**SERVICE LETTER**  
920232-06

**Strainer in HJ SIP valves**

**HJ E-SIP II / III**  
**Strainer arrangement (Pos. 18+19) = HJL item no. 951505**

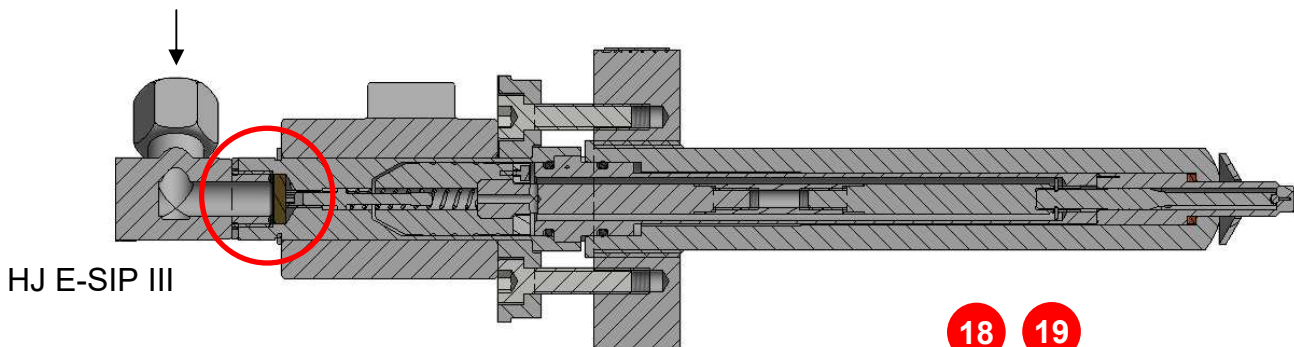
All our HJ SIP valves are from November 2013, delivered with a small 40µ strainer (19) under the union on the pressure side of the valve.

The strainer (19) is designed to ensure that no impurities will enter the valve during running-in, potentially leading to clogging of the valve.

We recommend that the strainer (19) is **only** used for running-in of a new HJ SIP system, or of overhauled SIP valves and that the strainer (19) **must** be removed after 500 running hours.

If the strainer (19) is not removed after 500 running hours, you risk that the strainer (19) blocks due to substances present in the oil, such as wax sticking to the strainer (19), and blocking this, with failure of the valve as a result.

The O-ring (18) and gasket (20 or 33) which are mounted together with the strainer (19) are also to be removed.
